**Re: Response to 2<sup>nd</sup> Submission Comments  
Traffic Impact Study Updated July 28<sup>th</sup>, 2022  
Hillsburgh Heights Inc.  
Proposed Residential Subdivision  
5916 Trafalgar Road North  
Town of Erin  
Town File No. 23T-21002, OP21-01 & Z21-09  
Our File No. W21081**

The Town of Erin, Ainley & Associates Limited and Dillon Consulting have provided comments to the Traffic Impact Study Update that is dated July 28<sup>th</sup>, 2022. Comments from the Town of Erin were provided in a letter dated November 1<sup>st</sup>, 2022, comments from Ainley & Associates Limited were provided in a comment matrix and comments from Dillon Consulting were provided in a memorandum dated December 16<sup>th</sup>, 2022, which are attached herein.

LEFT-TURN LANE WARRANT ANALYSIS  
FUTURE (2026) TOTAL TRAFFIC  
TRAFALGAR ROAD NORTH AT HOWE STREET/STREET 'A' - NB APPROACH

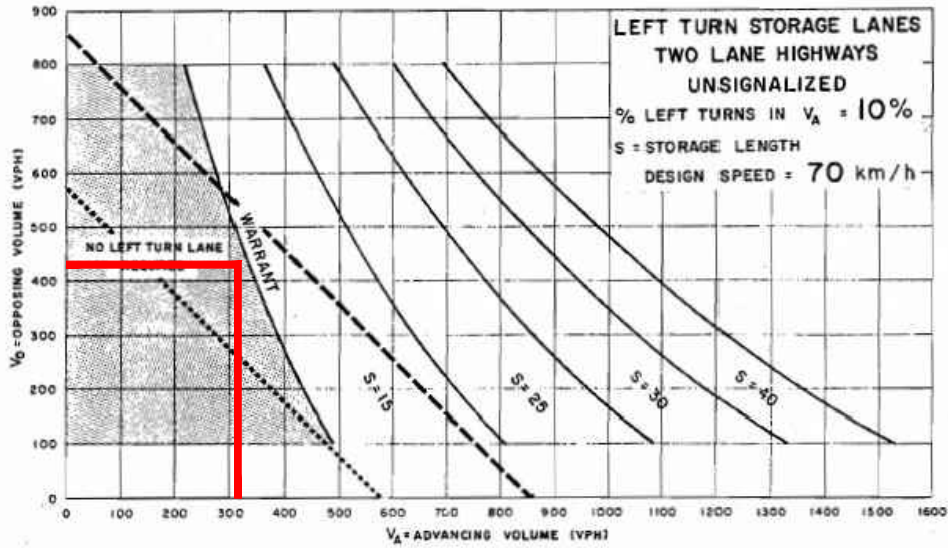
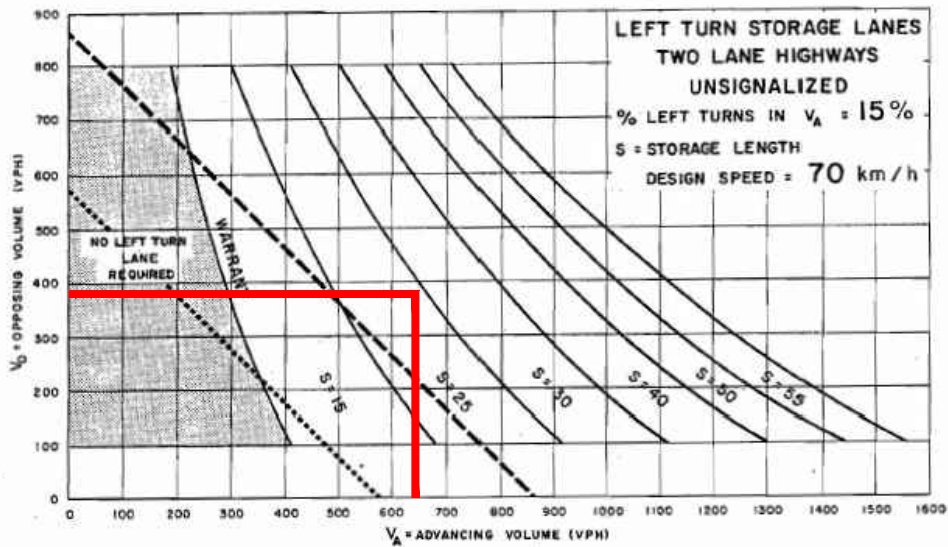
*Based on the 2031 PM total traffic volumes and MTO Design Supplement for TAC Geometric Design Guide for Canadian Roads, a 25 m northbound left turn lane on Trafalgar Road North at Street 'E' is warranted.*

*Partially done, the LT turn warrant shows a 25m length requirement, but only provides 15m.*

For the Trafalgar Road North at proposed Street 'E' and proposed Street 'A'/Howe Street at Trafalgar Road North intersections, although the left-turn lane warrant analysis warrants a left turning lane with 25 metres of storage at the northbound approach during the P.M. Peak Hour for the 2026 horizon year, since the Future (2031) Total Traffic Analysis indicates that the queue length for the turning lanes does not exceed 15 metres, we find that a storage length of 15 metres is appropriate.

For the northbound left turning movement at the Trafalgar Road North at Howe Street/proposed Street 'A' and Trafalgar Road North at proposed Street 'E' intersections, the left-turn lane warrant analysis that is illustrated in **Figures 34 and 35** was updated to reflect the revised volumes for the Future (2026) Total Traffic Scenario. The analysis followed the procedure specified in the Ministry of Transportation Ontario's Geometric Design Standards for Ontario Highways.

**PRELIMINARY GRADING PLAN**

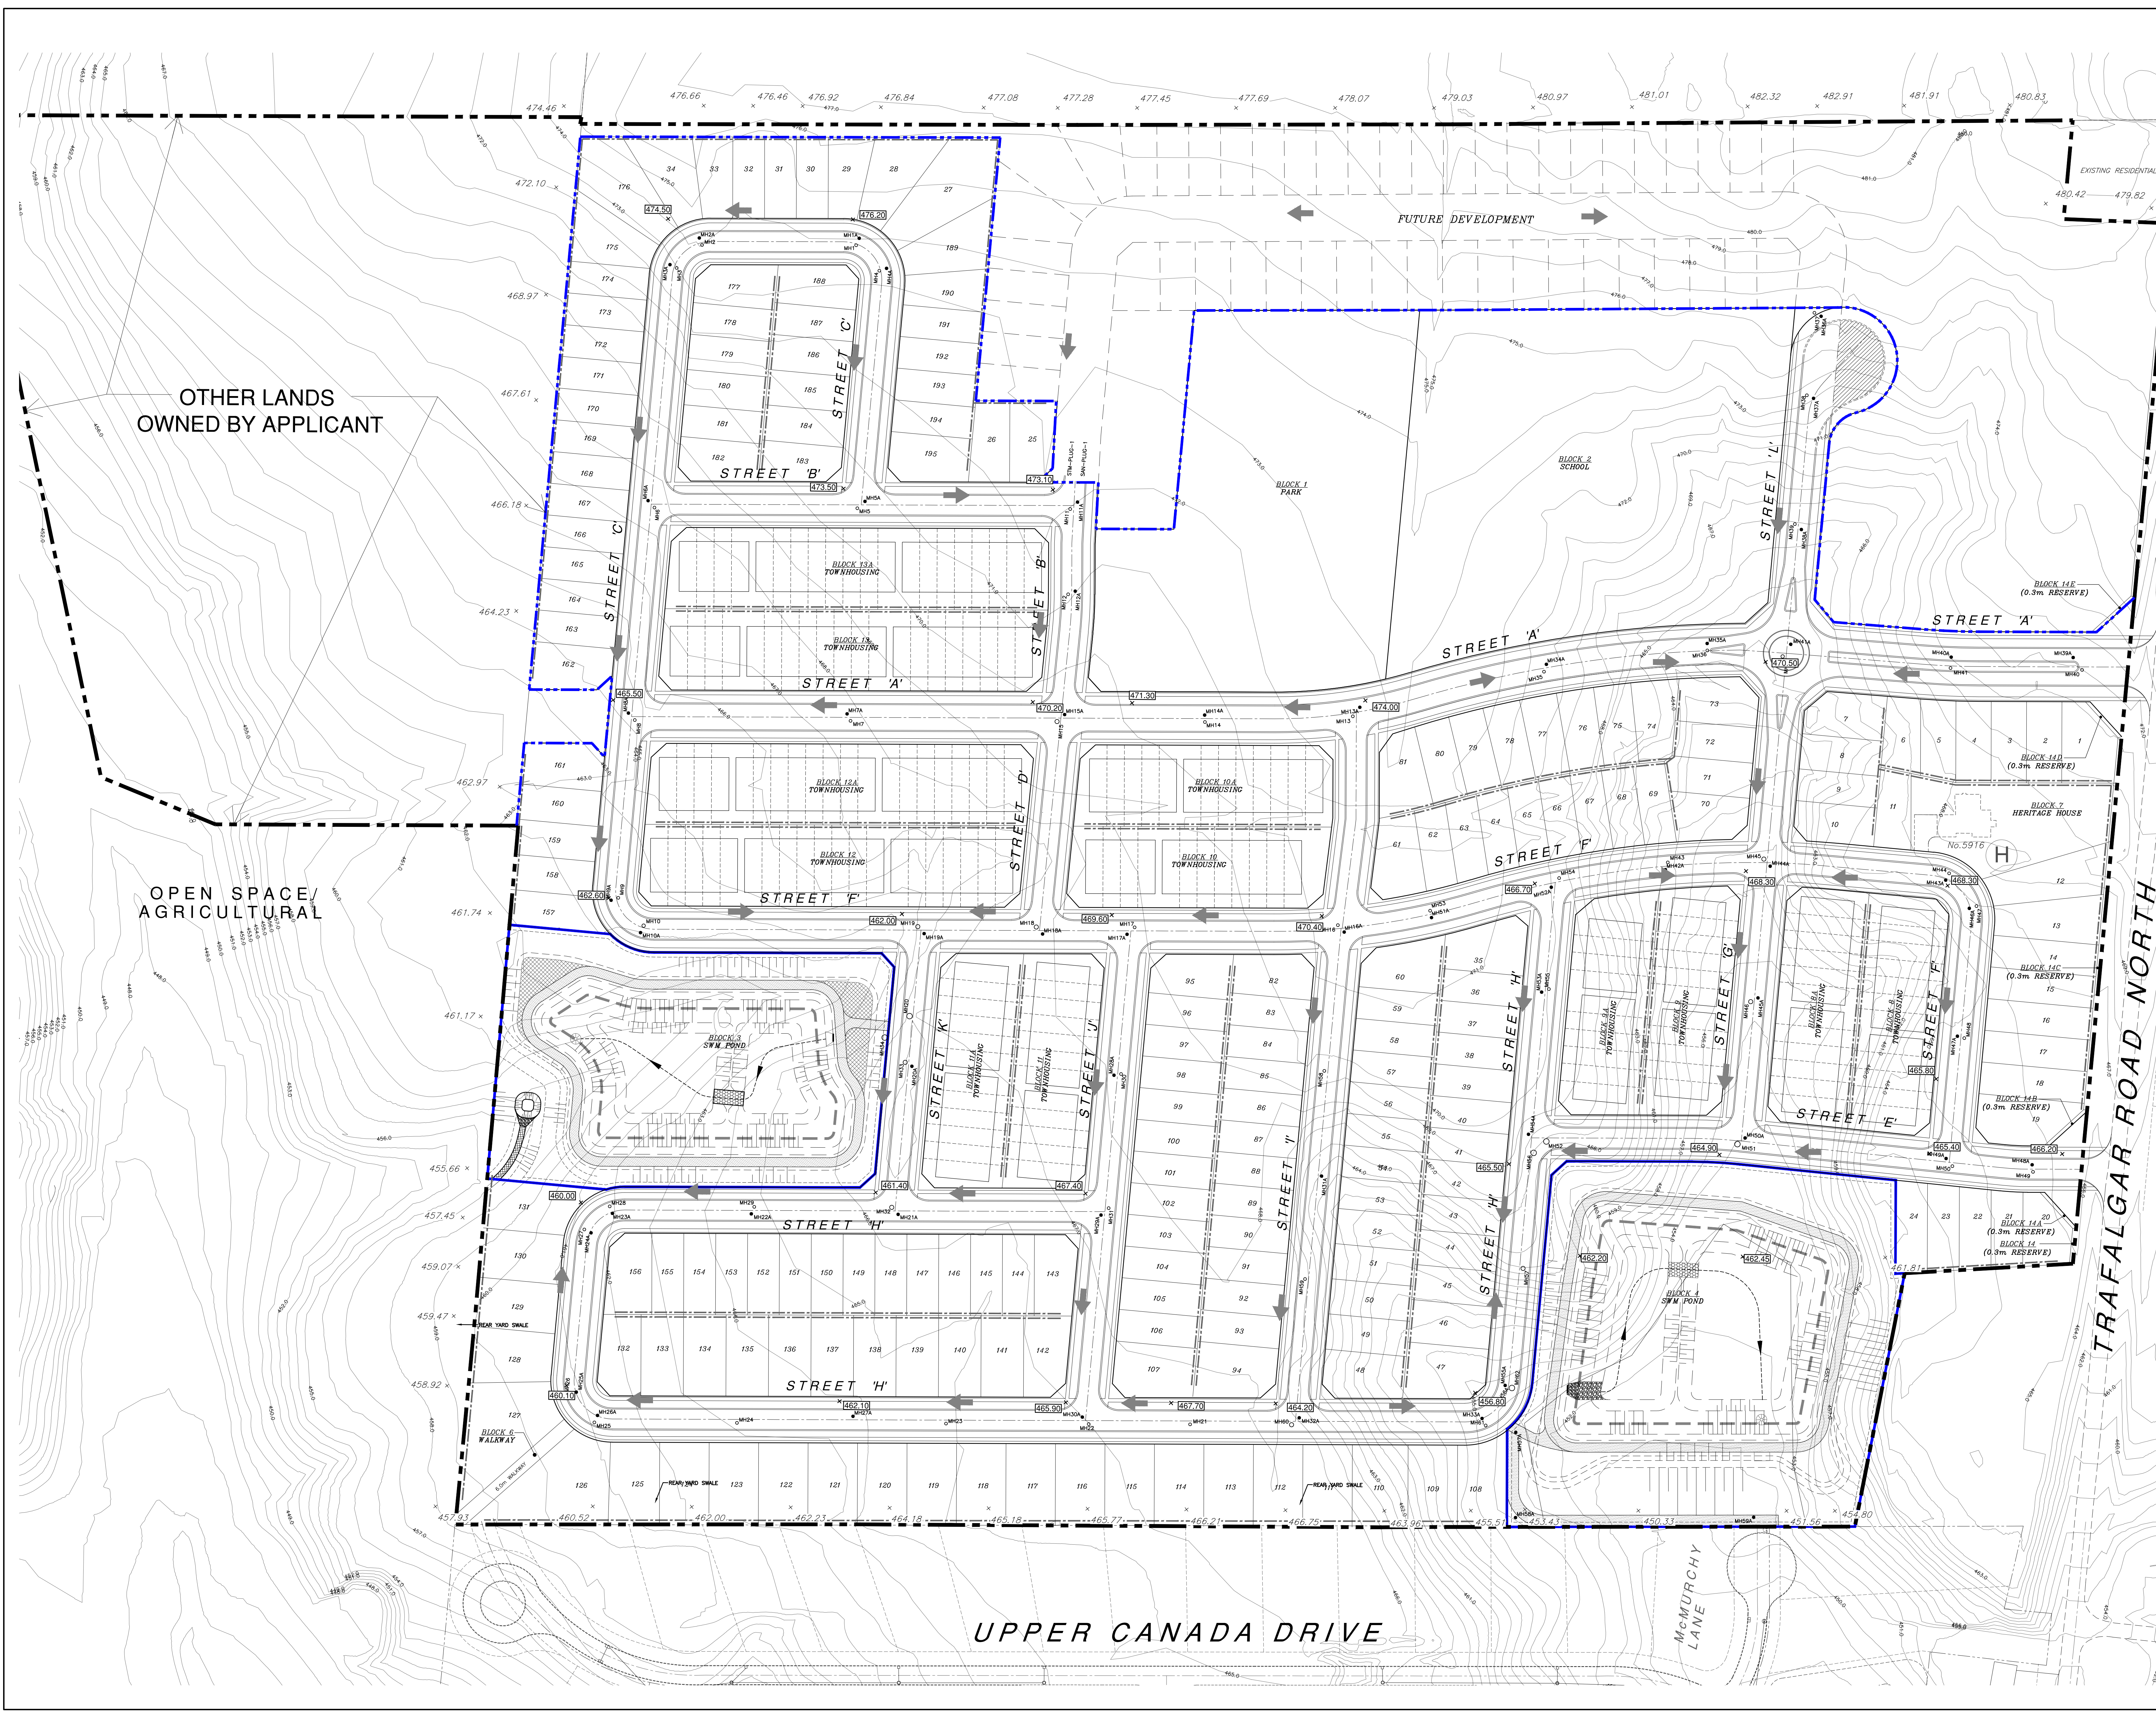
*The report does not provide specific rationale why a road connection to McMurchy Lane cannot be implemented rather than introducing a new (Street 'E') connection to Wellington Road 24.*

As discussed at our meeting on January 11<sup>th</sup> 2023 and as mentioned in the Traffic Impact Study Update and in the Response to Peer Review Comments Letter, a road connection with McMurchy Lane is not feasible due to constraints in grading. A SWM pond is also proposed at this location. To provide a better understanding of the constraints due to grading, the Preliminary Grading Plan (Drawing GR-1) provides the existing surface elevations on McMurchy Lane and within the subdivision.
